Private Owner Circular Letter 619 Issue I

Prohibition of Jacking or Lifting Wagons by Centre Couplers

Cut-outs in underframe Tail pin retaining plate -

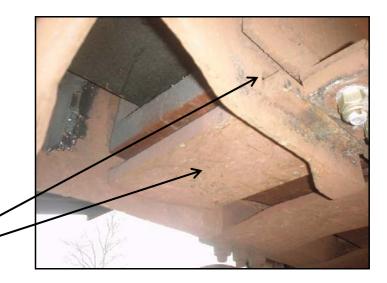
This instruction is applicable to PWRA registered wagons fitted with centre couplers where the coupler tail pin is retained by a pin retaining plate located in cut-outs in the wagon underframe, as shown by the adjacent photograph.

To reduce the possibility of adverse lifting loads being transmitted into the centre coupler tail pin support plate and adjacent underframe on these wagons, the lifting or jacking of this design of wagon by any means involving the centre coupler is **prohibited**.

Lifting or jacking of wagons via the centre coupler is only permitted in cases where the Owner can demonstrate the wagon design (and specifically tail pin support plate area) has been designed to accommodate lifting loads via the coupler and underframe, and where appropriate lifting controls are implemented.
